### PLANNING COMMISSION MEETING

A. Redevelopment at 9328 Highland Road

Request: Preliminary Site Plan Approval

RE: 9328 Highland Road- Commercial Building with Drive Thru- Preliminary Site Plan Review - 1st

LIGHTING PLAN

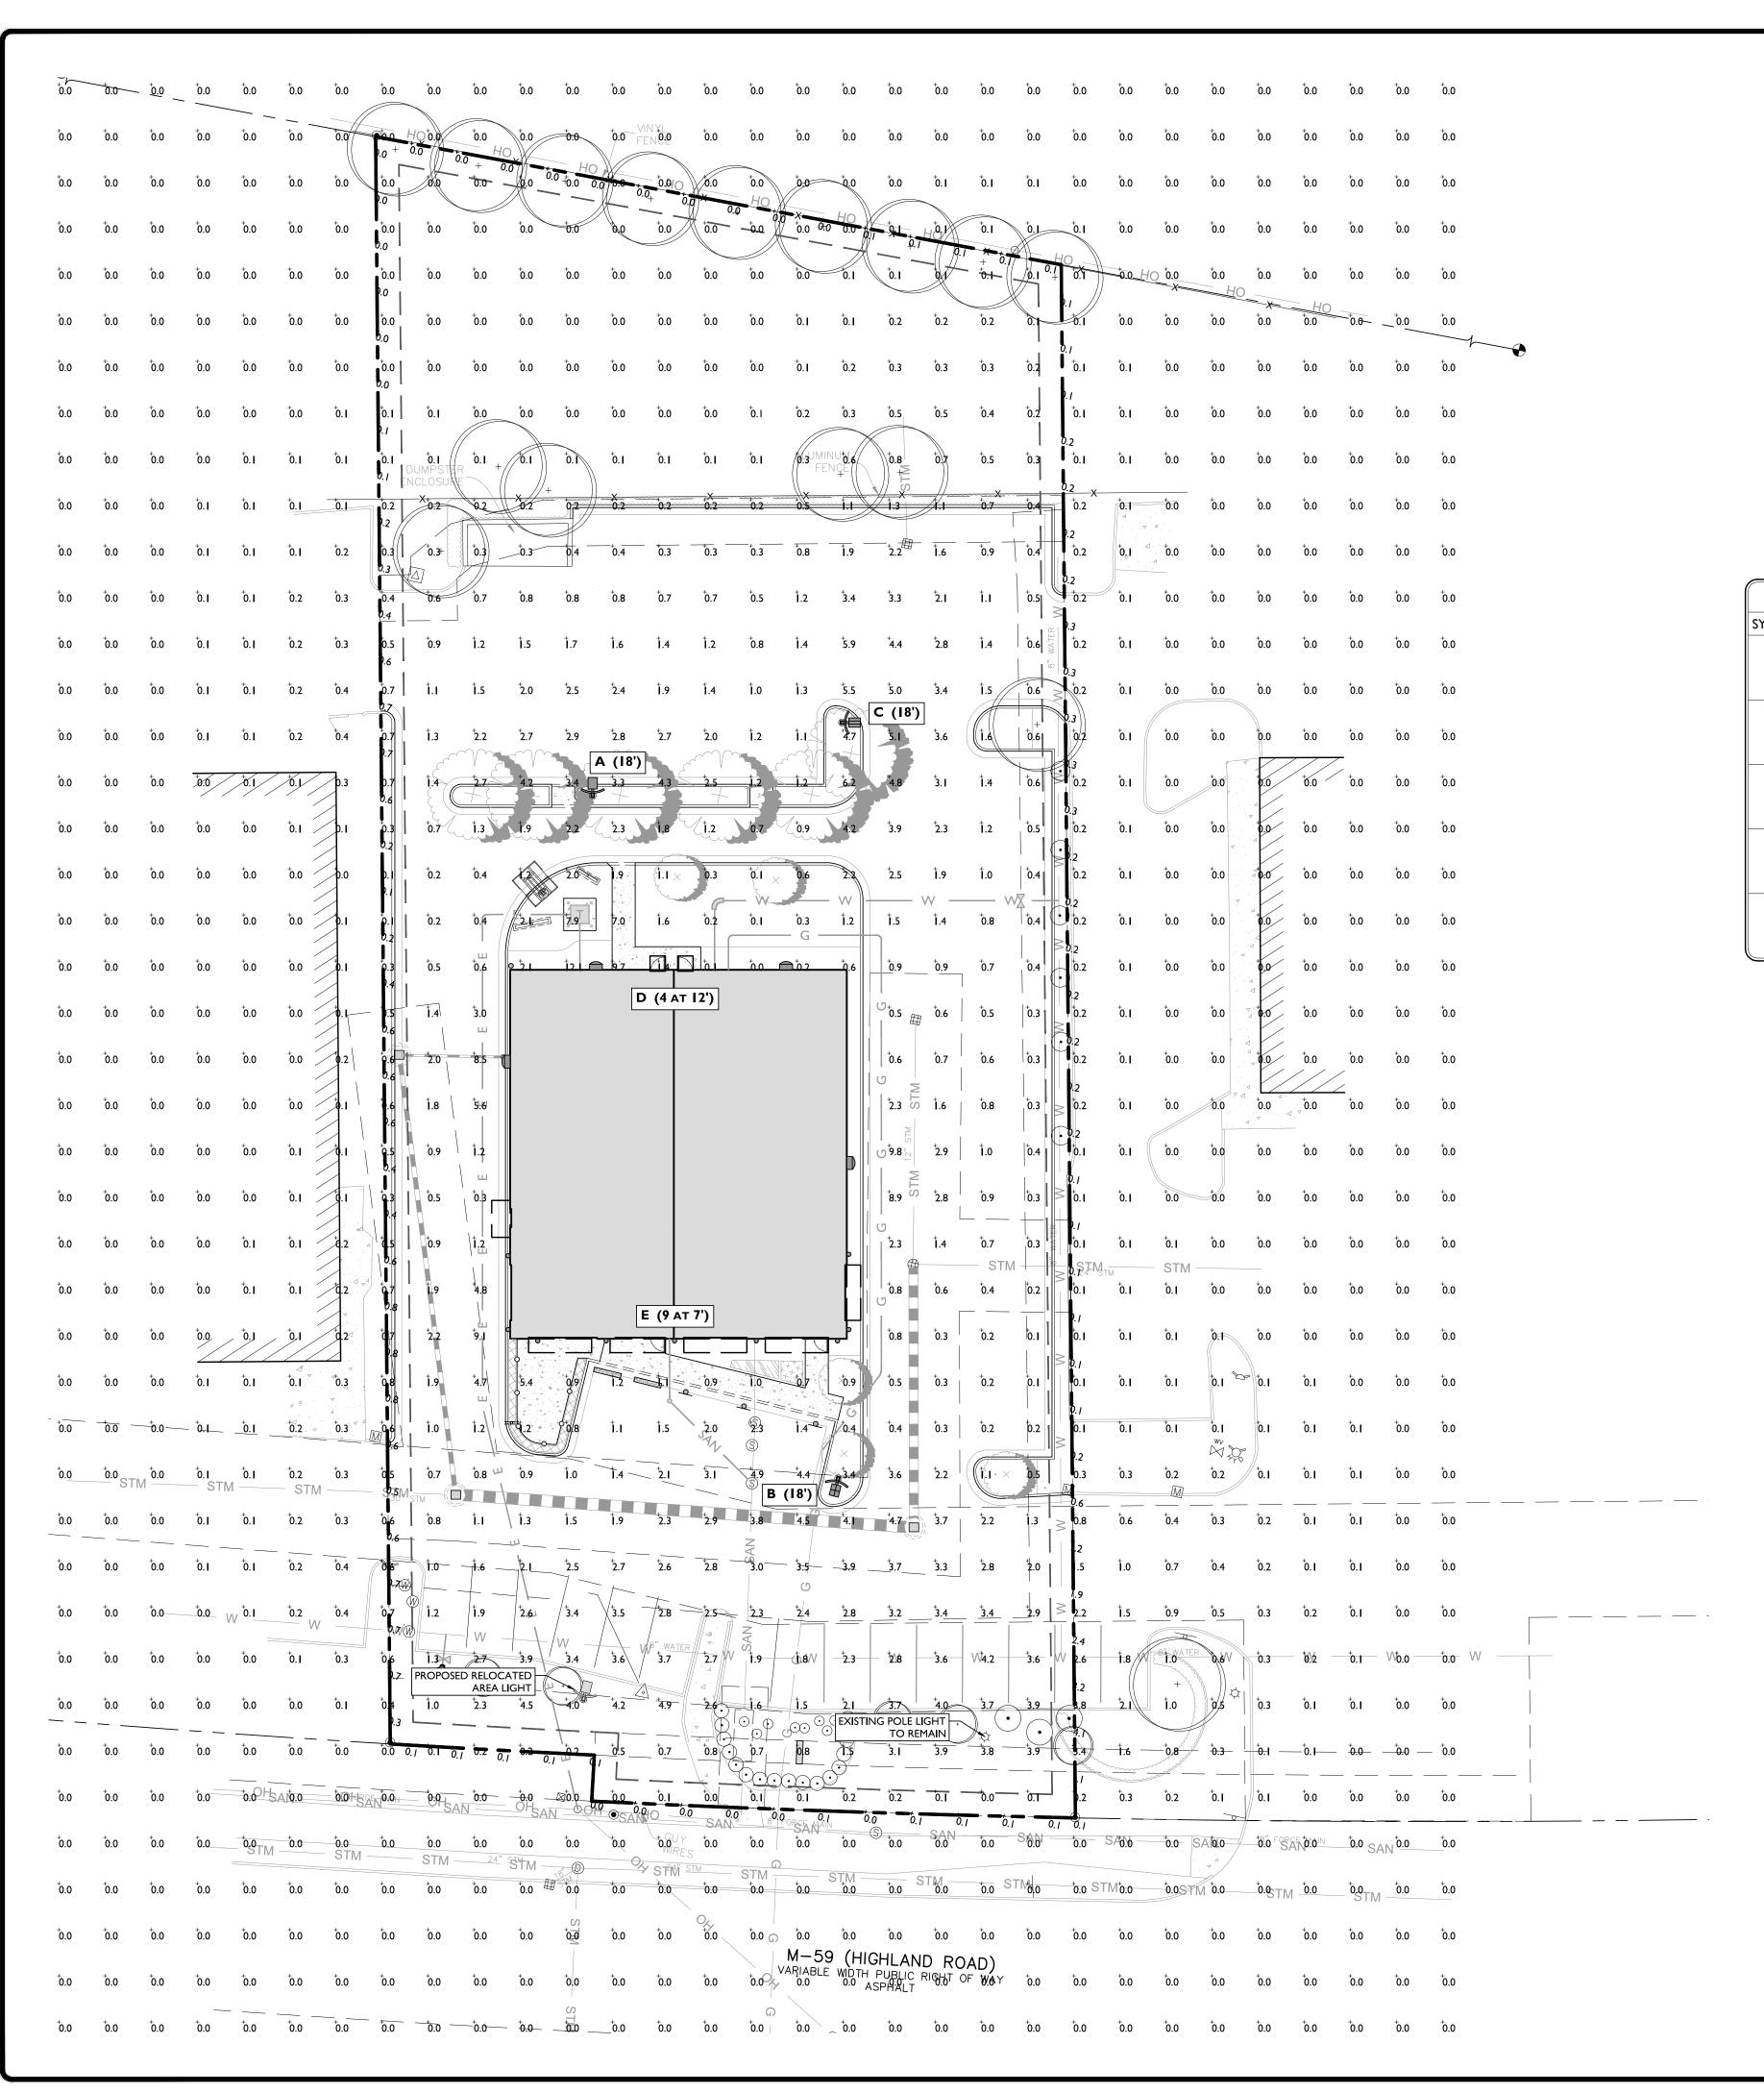
- 7. **Lighting.** Section 5.18(G) of the Zoning Ordinance includes the standards for outdoor lighting. A photometric plan was submitted. The plan states that the maximum foot candles at the property line exceed the permitted maximum of 1-foot candle and a notation that this is an existing light level. **The Planning Commission should determine whether or not this level of light is acceptable because it is existing.** The highest light levels occur along the front lot line by an existing pole light and a (proposed) relocated area light. If any existing fixtures are relocated or replaced, they should be brought into compliance with ordinance standards,.

Nine, rubbed bronze anodized sconce fixtures are proposed on the building. Article 6, Section 6.8.E.vii of the Zoning Ordinance states *floodlights, wall pack units, and other types of unshielded lights, and lights where the lens or bulb is visible outside of the light fixture are not permitted.* The intent is wall-mounted decorative or architectural lighting must be fully shielded and directed downward – up-lighting or outward shining lighting are not permitted. **The petitioner should revise the proposed light fixtures with those that meet the Ordinance requirements.** Four wall packs are proposed; two on the rear elevation and one on each side elevation. These wall packs are in compliance with the Ordinance as they are directed downward.

- 9. Dimension of existing pathway along Highland Road added to final site plan.
- 10. Determination by the Planning Commission as to the appropriateness of the existing level of lighting, which exceeds the Zoning Ordinance maximum for foot candles at the lot lines and internally within the site.

- 11. The petitioner should revise the proposed (wall sconce) light fixtures with those that meet the Ordinance requirements.
- 12. The applicant to provide detail on the wall sign calculations with respect to the front façade area and the area of the proposed wall signs.
